PIER 7A STRUCTURAL REPAIRS PROJECT NO. 091197 CONTRACT NO. 069408

RED LINE DRAWINGS

6500 G1.0 SHEET 1 OF 17	CONTRACT/CONS: 091197 M. ID: 091197 PHASE: BID SET	TOWNSHIP: 21 N RANGE: 3 E SECTION: 34 DATE: 19-39' @ TIDE 22.19.33 DAT-HRZ: NAD 83-07 VERT: AS NOTED DRAWING SCALE: AS NOTED PARCEL: 27	PIER 7A STRUCTURAL REPAIRS COVER SHEET AND DRAWING LIST	APPROVED:	RHM 9/25/12 CHECKED BY: DATE	9/25/12 SUB: DATE	9/25/12 PROJ. ENGR: DATE	9/25/12 PRINTED BY: valendy Feb 12, 2013	9/25/12 PORT ADDRESS: ONE SITCUM PLAZA TACOMA, WA 98401-1837
				Parametrix ENGINEERING, PLANNING, ENVIRONMENTAL SCIENCES 1019 39TH AVENUE SE, SUITE 100 PUYALLUP, WASHINGTON 98374 T. 253.604.6600 F. 253.604.6799 www.parametrix.com	Port of Tacoma P.O. BOX 1887 TACOMA, WA 98401-1887				
				MARK: 1	REVISION: 1	ADD NEW SHEETS	BY: RHM	APPR: RHM	DATE: 2/6/13

1 BERTH A PLAN - BENTS 1-11 SCALE: 1/8"=1'-0"

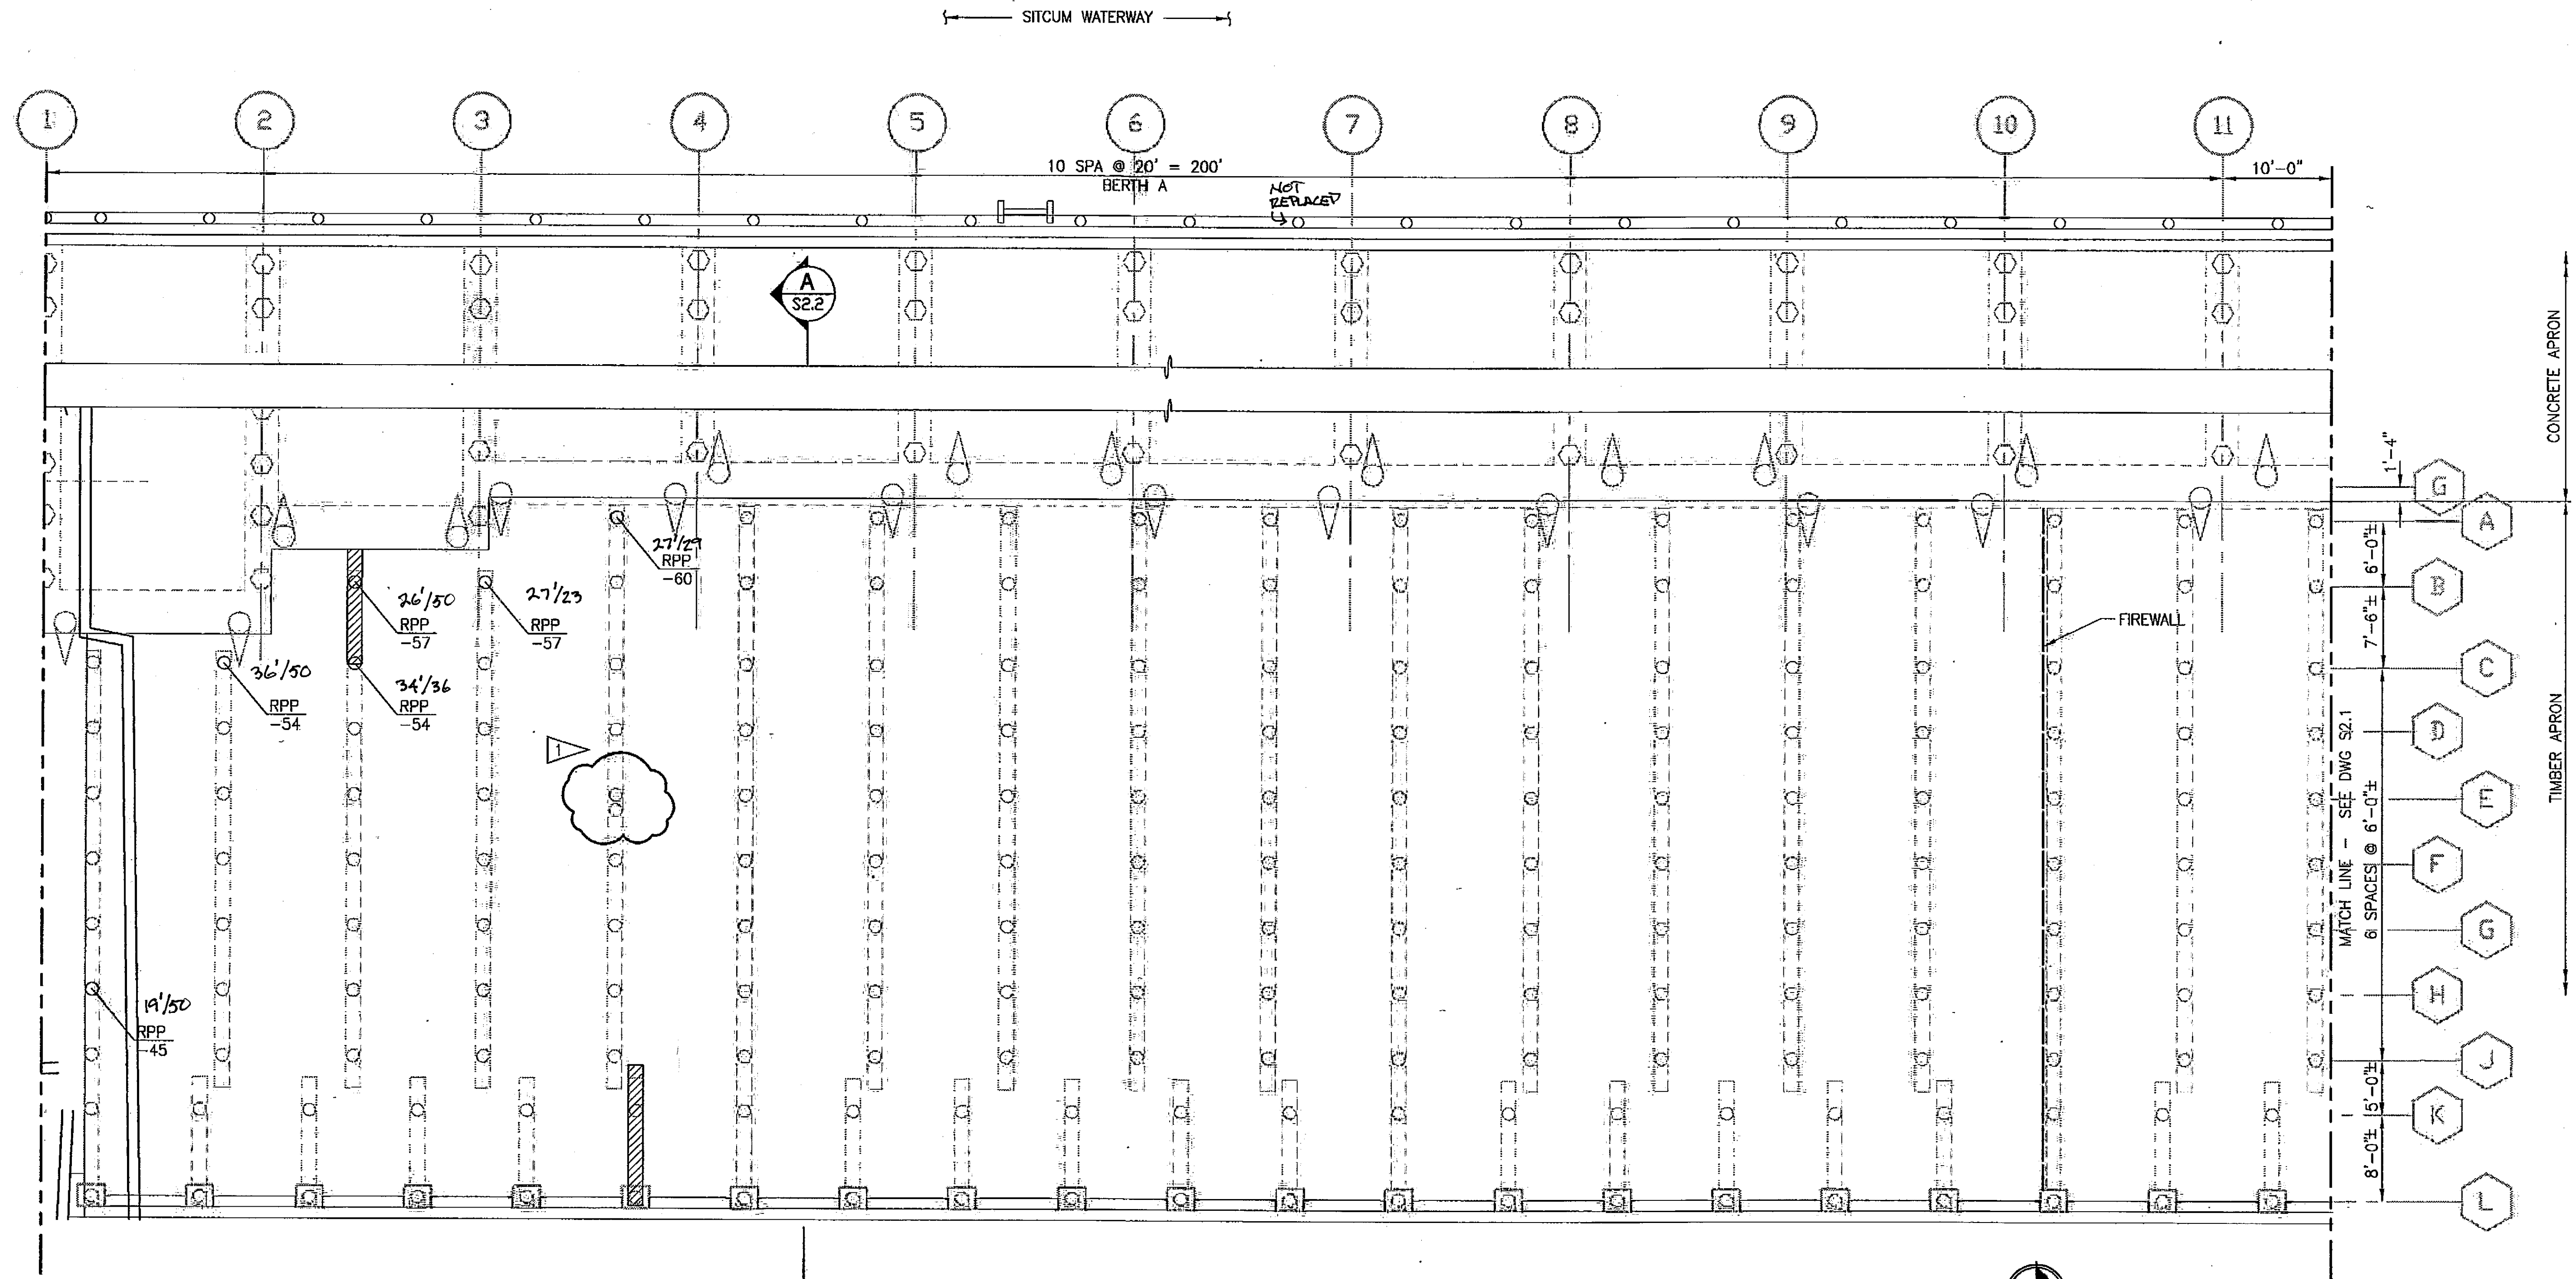
MARK: 1 REVISION: REMOVE RPP GRID 4
BY: RHM
APPR: DATE: 2/6/13

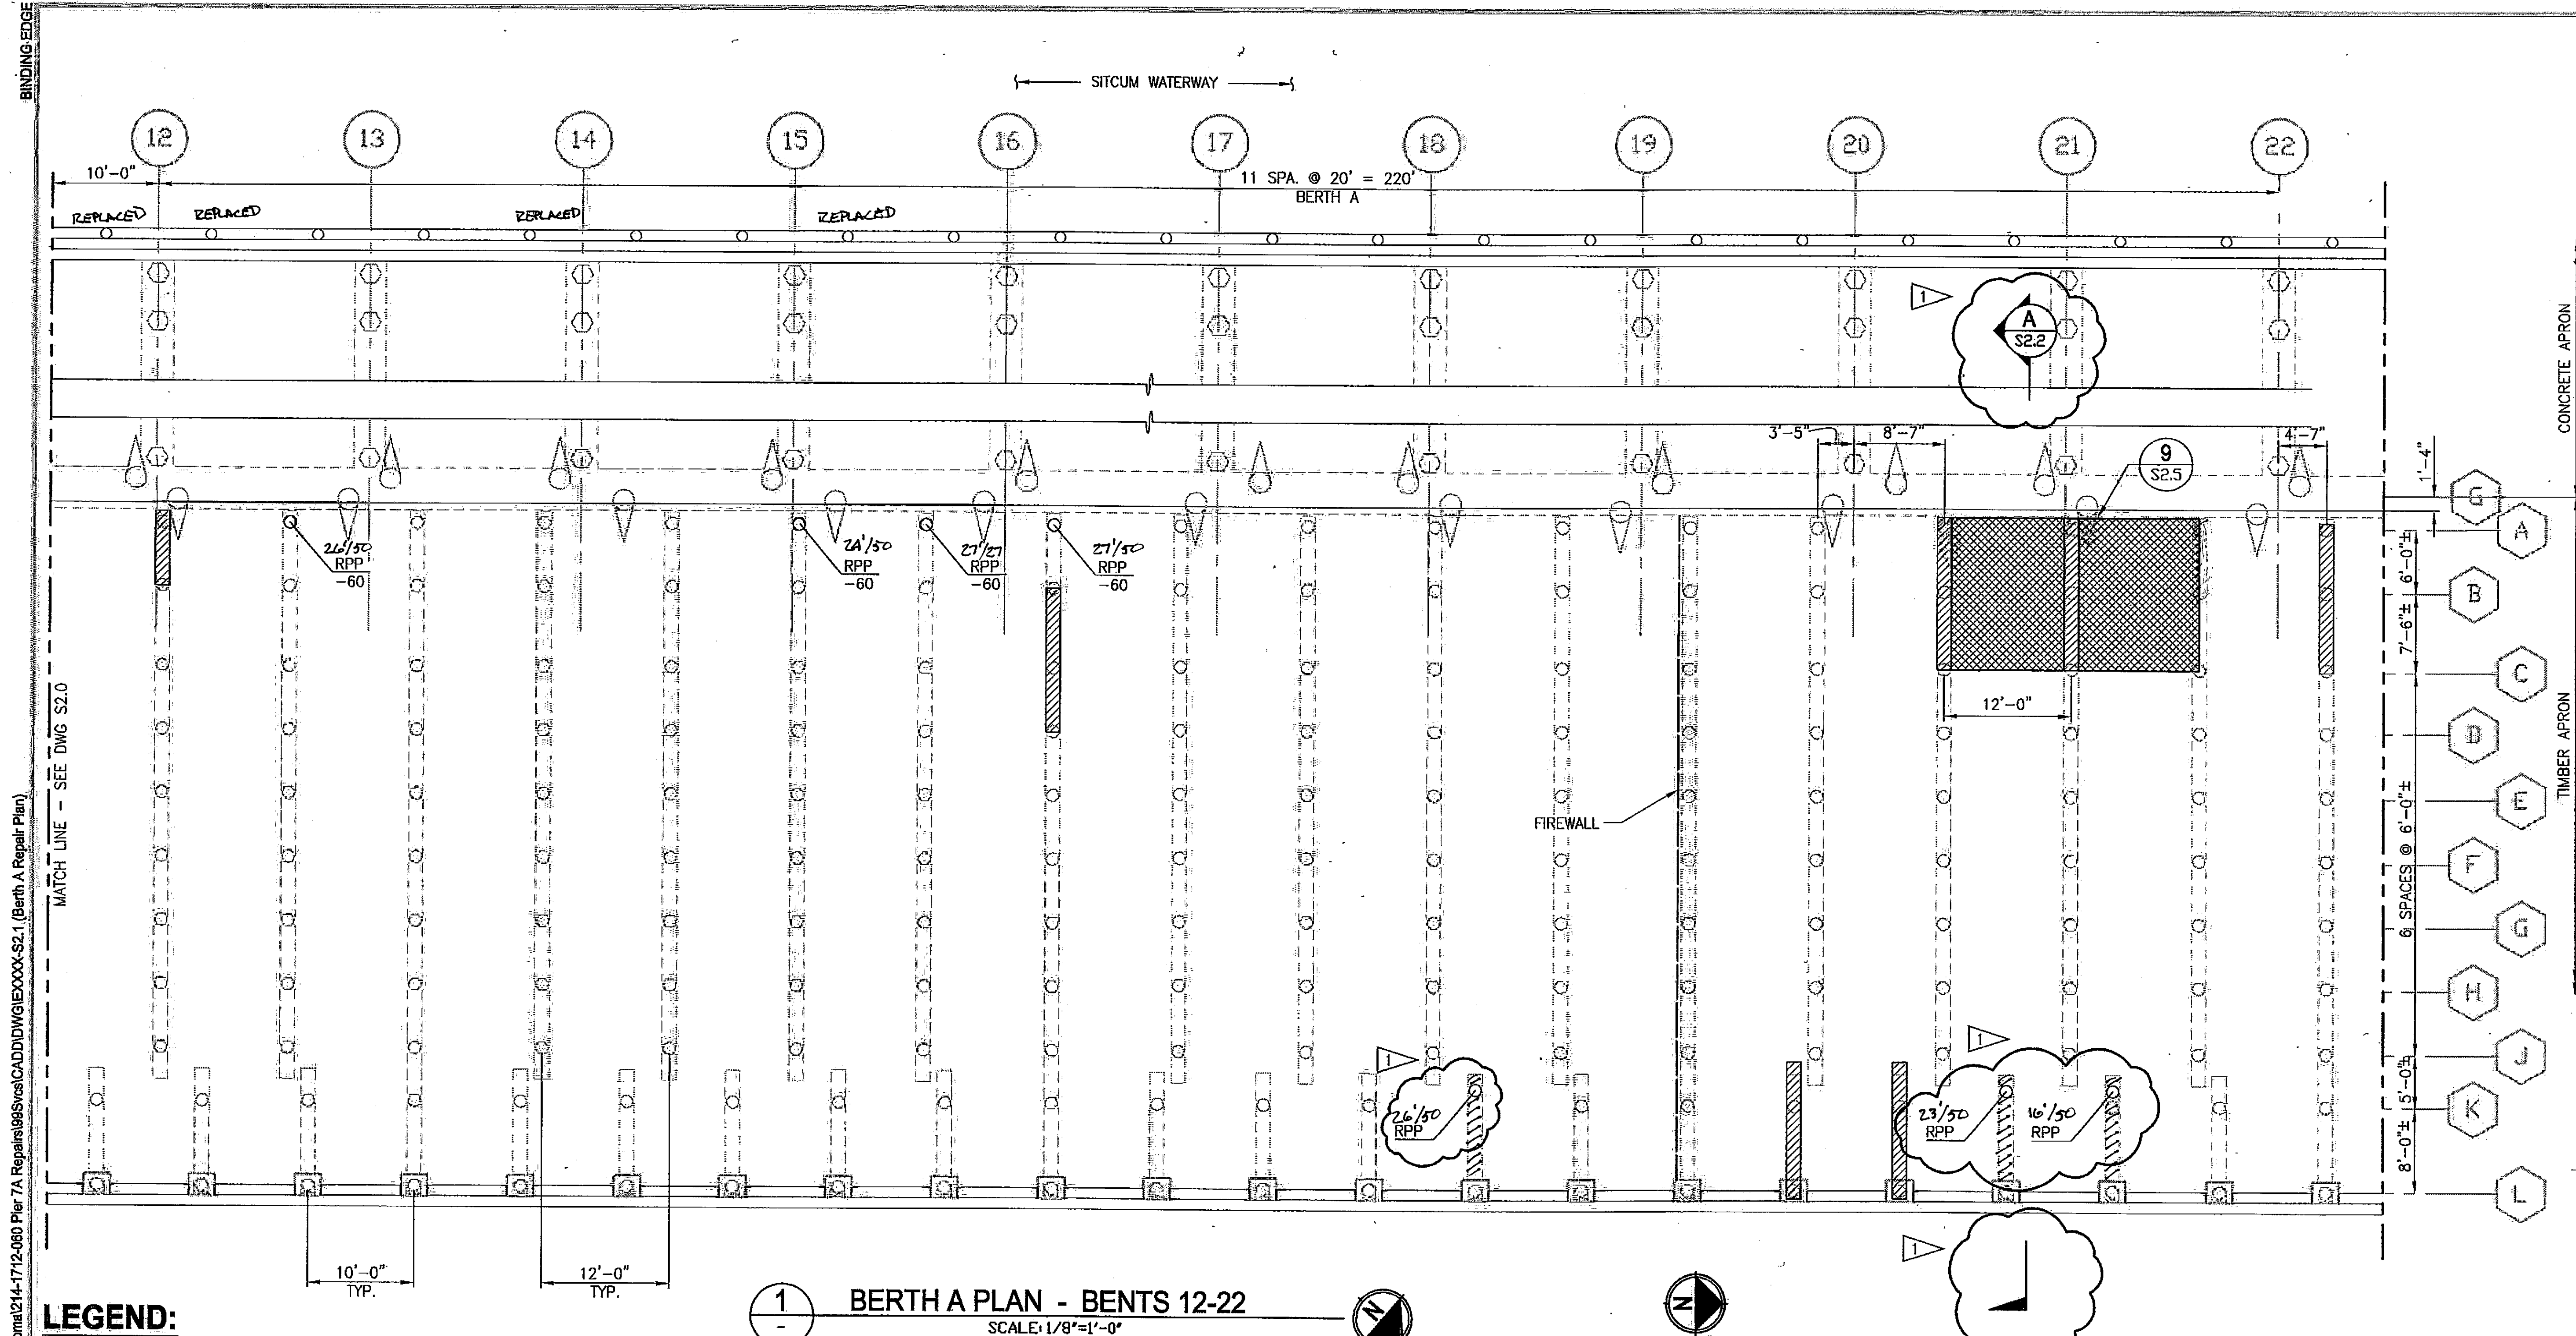
6500 S2.1 SHEET 5 OF 17	PIER 7A STRUCTURAL REPAIRS BERTH A REPAIR PLAN				APPROVED: RHM 9/25/12 CHECKED BY DATE SUB 9/25/12		Port of Tacoma ENGINEERING, PLANNING, ENVIRONMENTAL SERVICES 1700 10TH AVENUE, SUITE 100 TACOMA, WA 98401-1837 P.O. BOX 887 TACOMA, WA 98401-0887 WWW.PORTOFTACOMA.WA.GOV	
	TOWNSHIP: 21 N		RANGE: 3 E		SECTION: 34		BY: RHM	
	DATE: 09/19/17		DATE: 09/25/12		DATE: 09/25/12		DATE: 09/25/12	
	M. ID: 09197		M. ID: 09197		M. ID: 09197		M. ID: 09197	
PHASE: BID SET		DRAWING SCALE: AS NOTED		PORT ADDRESS: ONE SITCUM PLAZA		CHANGE PP TO RPP		
				TACOMA, WA 98401-1837		2/6/13
